**RE: SUBMISSION TO THE DRAFT RIVERSTONE EAST GROWTH PRECINCT PLANNING  
FRAMEWORK**

Invoke Property has reviewed the Draft Riverstone East Growth Precinct Planning Framework that was placed on exhibition between 12 August 2015 and 18 September 2015 and provides this submission to the Department of Planning and Environment (DoP&E) requesting consideration be given to the amendment of the Draft Indicative Layout Plan (Draft ILP) to remove the proposed local park shown at the centre of the low-density area that is generally bound by Tallawong Road to the east, Gunatawong Road to the north, Clarke Street to the west and the medium density/sports field area to the south (**Figure 1**).

**Figure 1** – Current Draft Riverstone East ILP showing Location of Land that is the Subject of this Submission

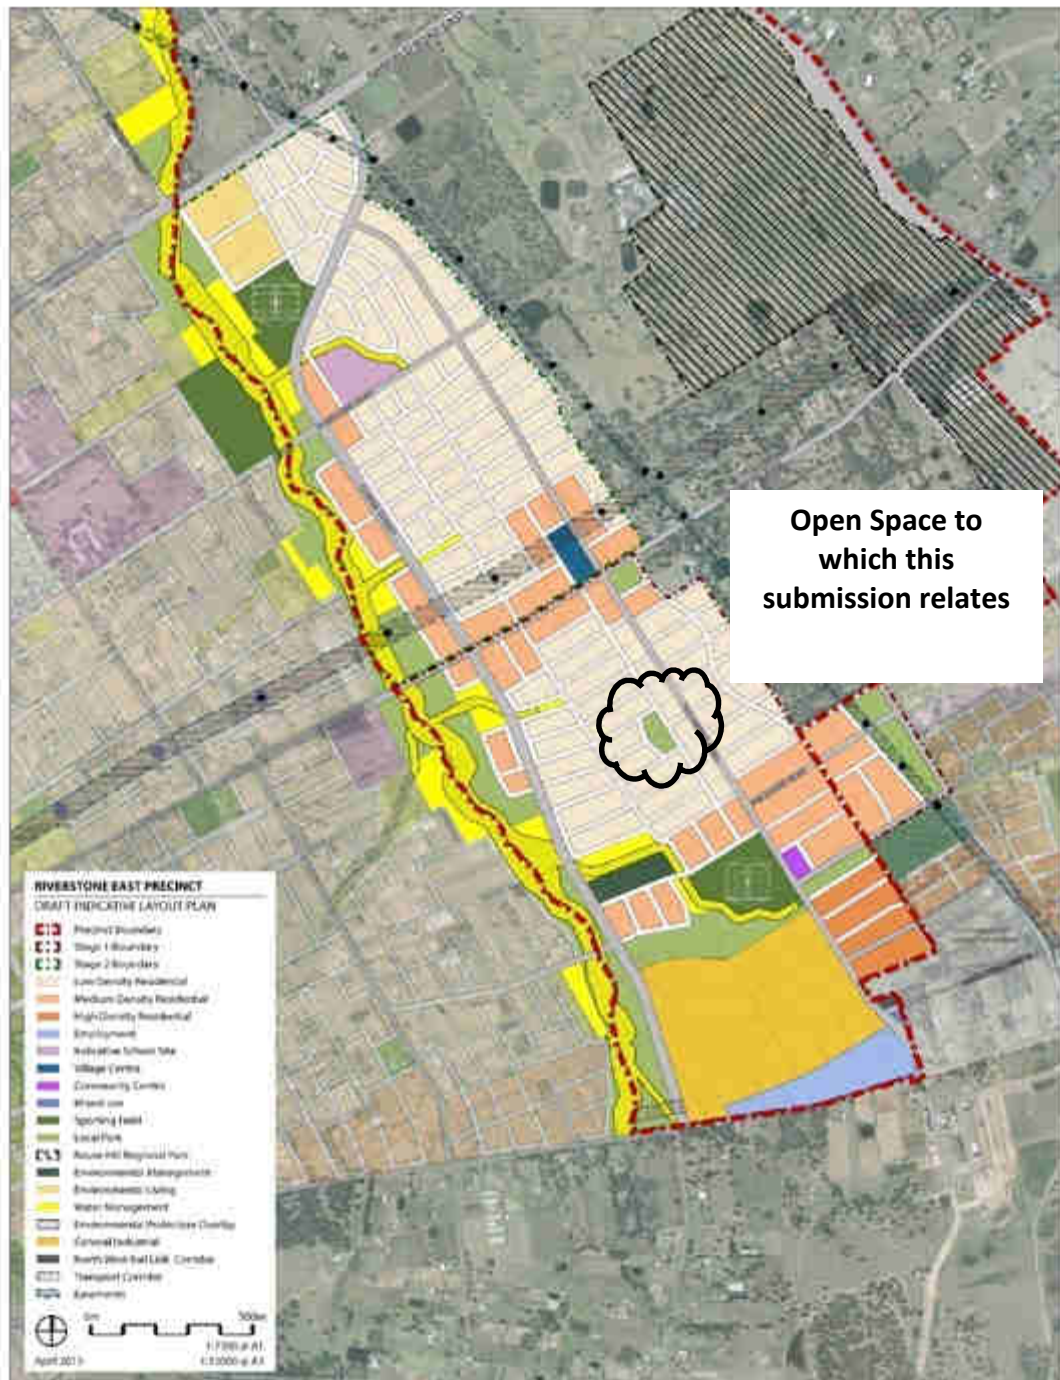
While the importance of open space throughout the Precinct is recognized, the provision of the local park at the centre of this southern low density area is considered excessive given this park is very close to other extensive tracts of open space including significant sports fields. The proximity to this extensive open space has not been given sufficient consideration in the design of the Draft ILP, whereas areas to the north are recognised as being deficient in access to local open space.

**Figure 2 – Areas within 500m Distance from Open Space following removal of Local Park within the Southern Low-Density Area**

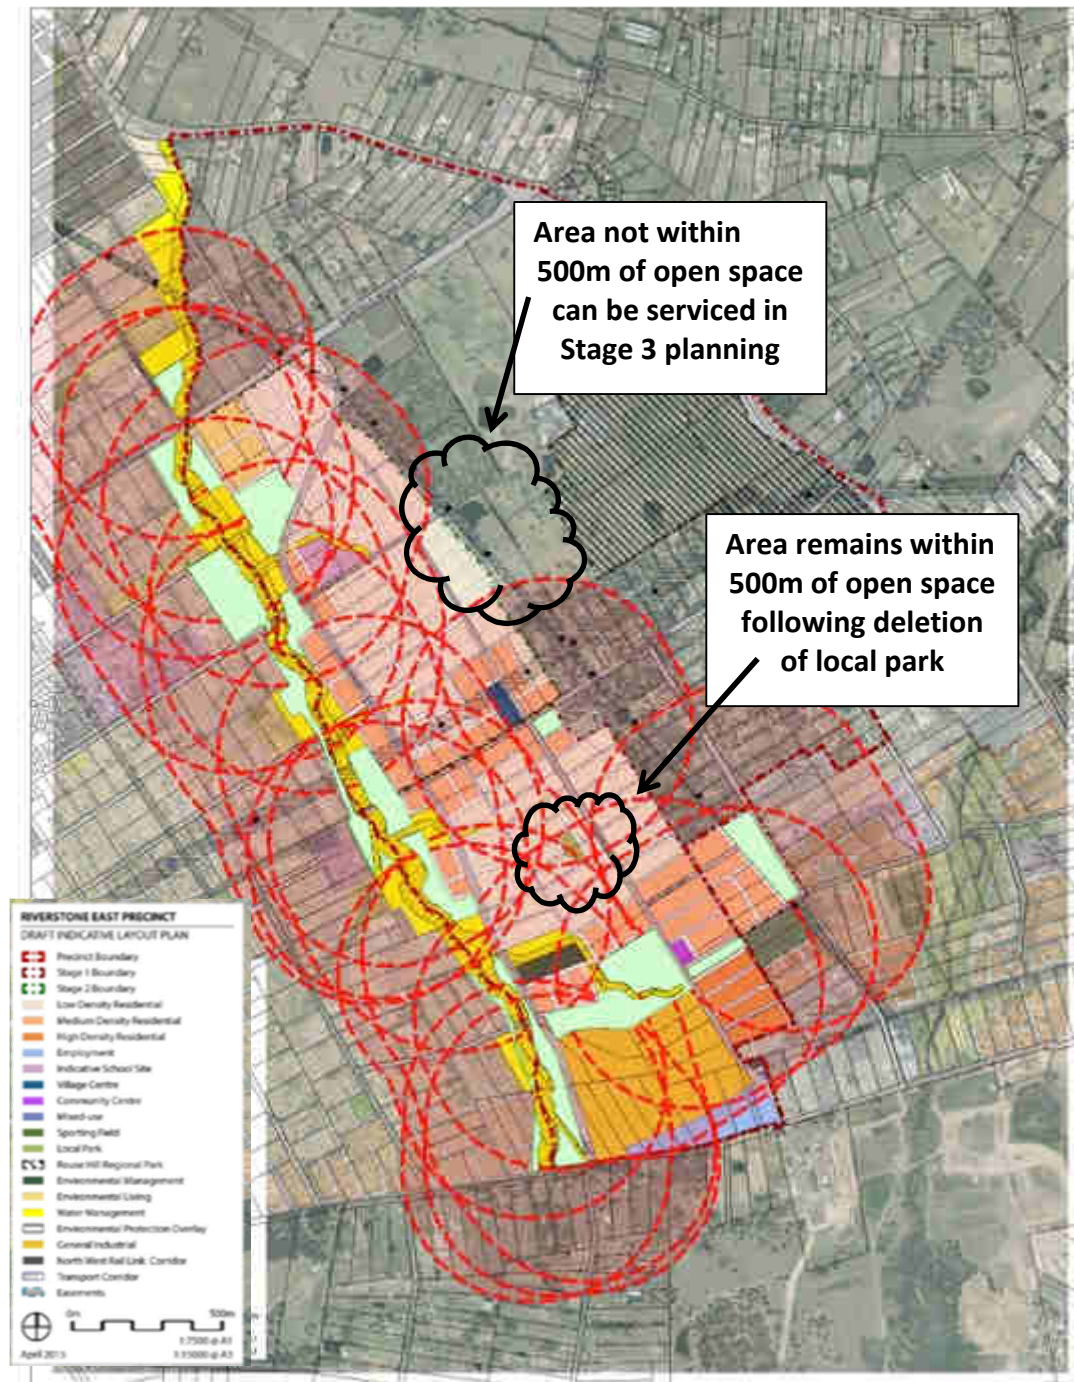
An investigation of the distance between proposed residential-zoned land and proposed open space has been undertaken and reveals that without the local open space proposed at the centre of the low density residential area, all residents in this area will remain within 500m proximity of an open space area (**Figure 2**).

This outcome suggests that the addition of the local park is redundant and not positioned in the most efficient and logical site within the growth centre. No requirement for a park in this location has been justified in any meaningful way.

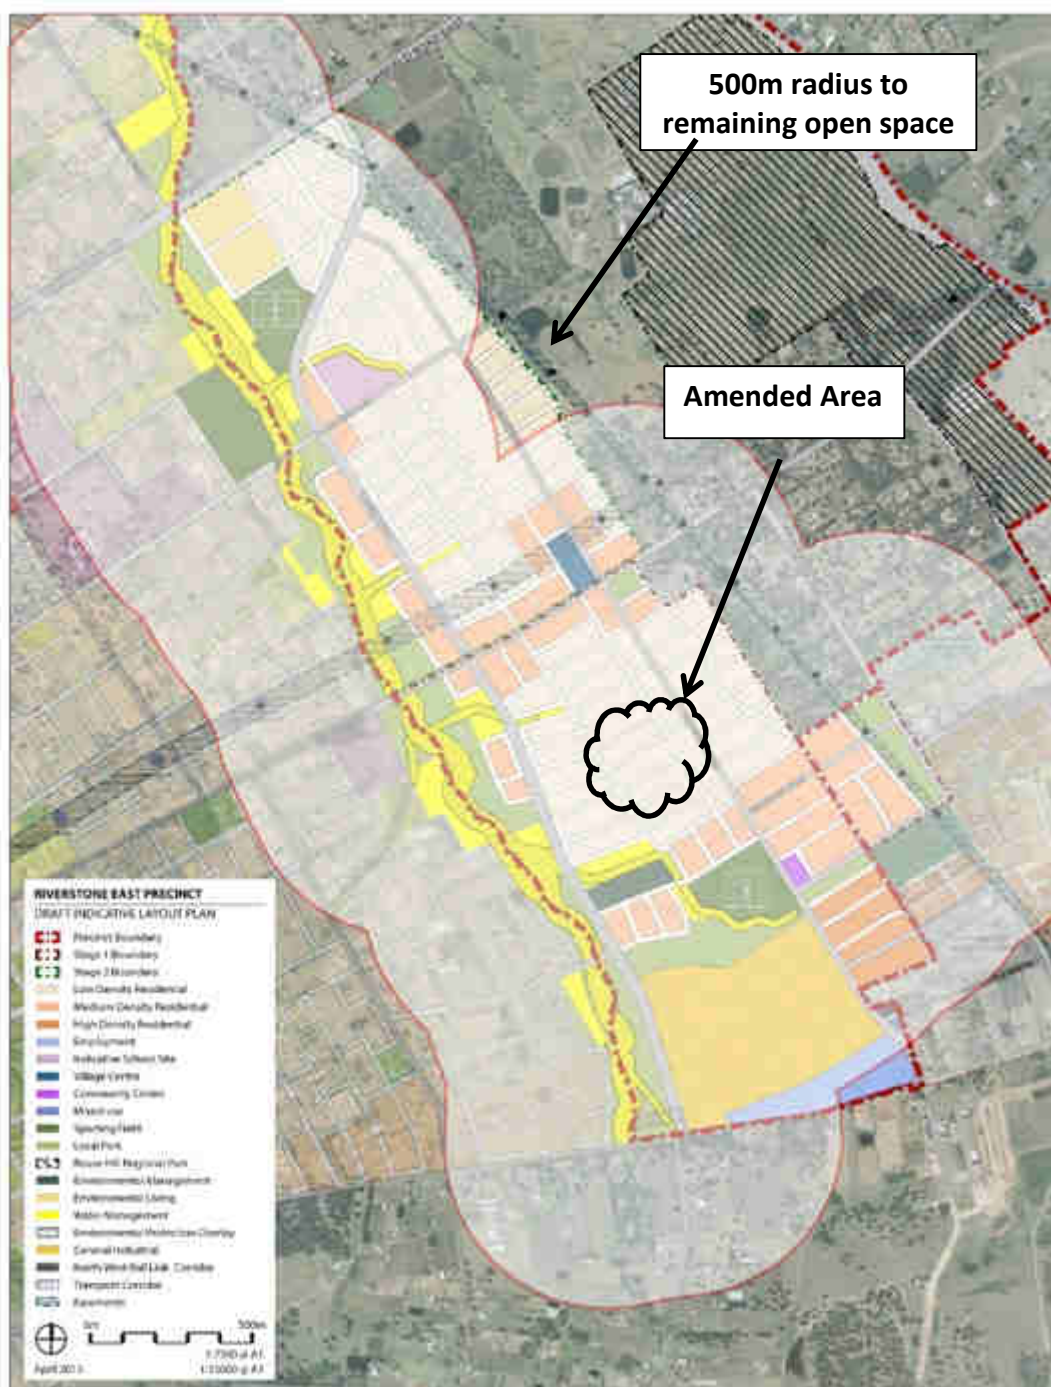
In essence, the current position of the subject open space is not located in an area where a 'gap' is identified in open space provision and should be relocated to future Stage 3 planning to address the open space void in the northern half of the Precinct at a later stage (**Figure 3**).

**Figure 4**

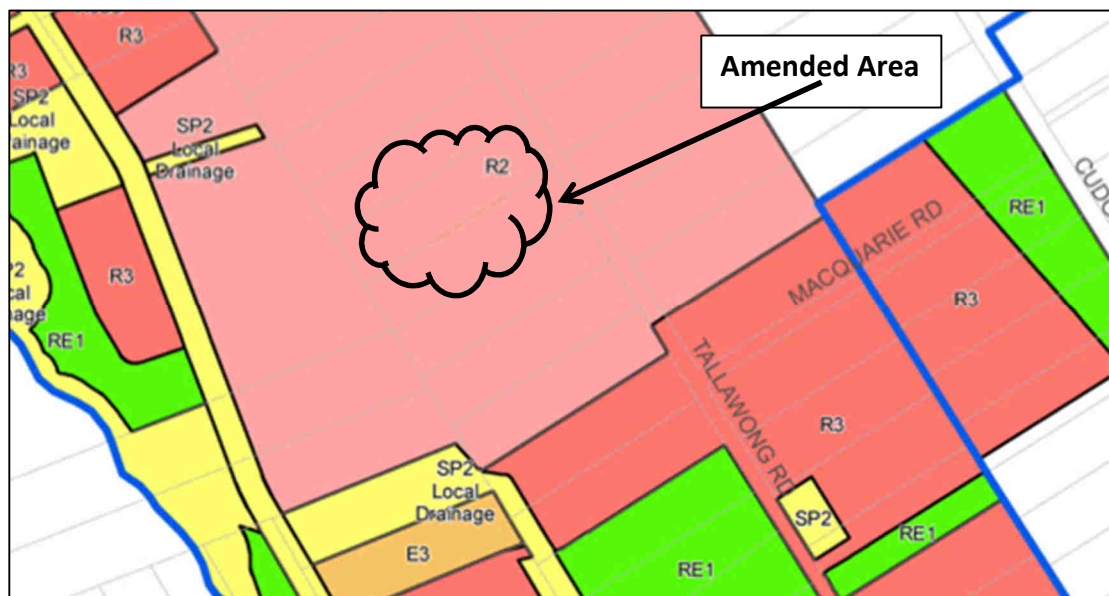
To enable the relocation of the open space as outlined in this submission, the Land Zoning Map will require amendment as indicated in **Figure 4**.

**Figure 5** – Amended Riverstone East Precinct Height of Buildings Map

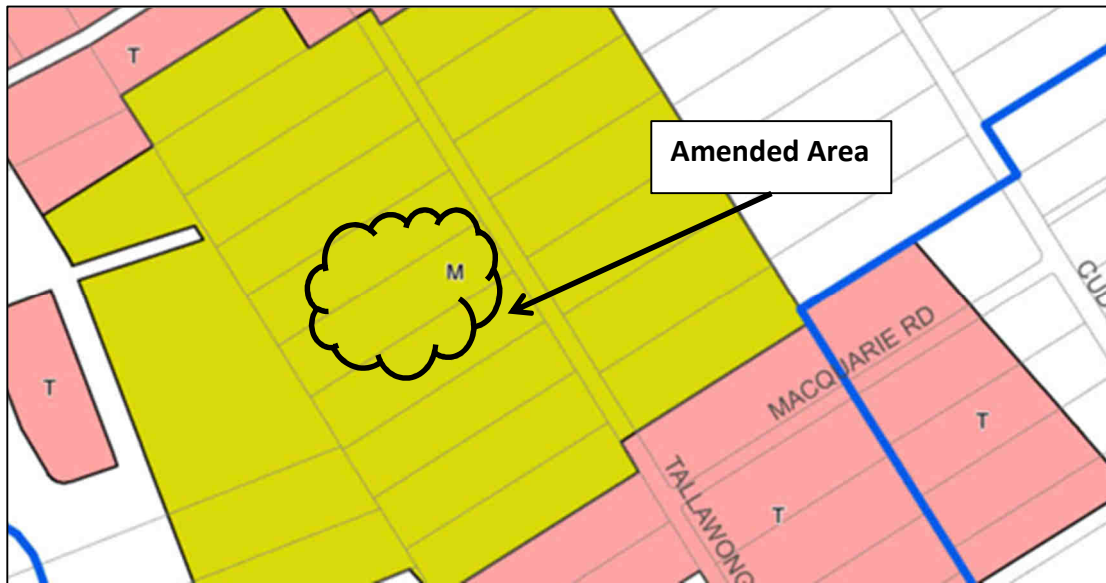
To enable the relocation of the open space as outlined in this submission, the Building Heights Map will require amendment as indicated in **Figure 5**.
